DEVIATION REQUEST AND DECISION FORM

Project Name : Sterling Ranch Sand Creek Channel Construction Drawing Review CDR 20-4
 Schedule No.(s) : 5227301021, 5233309027, 5228000030 & 38, 5233301001 5233301016 &17
 Legal Description : See Exhibit B – Legal Description

A deviation from the standards of or in Section **ECM section 3.3.3 Open Channel Design Standards** of the Engineering Criteria Manual (ECM) is requested for the Sand Creek Channel Design – Low Flow Channel Capacity.

Typical Channel Cross Section

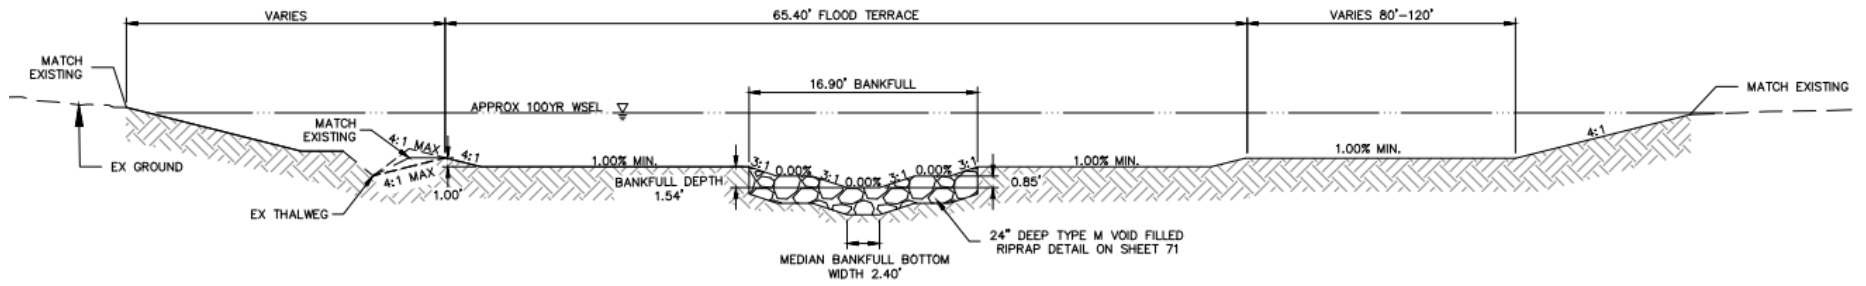
Per ECM Section 3.3.3 Item B. All open channels shall conform to DCM Volume 1 and Volume 2. Per DCM Vol. 1 chapter 6.5 Open Channel Design Criteria, Section 3 Channel Cross Sections, the Low Flow Channel shall generally be designed to convey 10% of the 100 year storm.

The geomorphology study recommended a much smaller “low flow” channel section.

See Exhibit A for a representation of the “geomorphologist recommended” low flow channel cross section.

The proposed low flow channel in the Sterling Ranch Sand Creek design is approximately 16.9 feet wide and 1.54 feet deep and has a capacity of 29 cubic feet per second. The low flow channel is armored with 24” deep type M void filled rip rap.

Note: If the ECM Administrator decides to accept maintenance of the channel, full stabilization and vegetation density will be required prior to preliminary acceptance
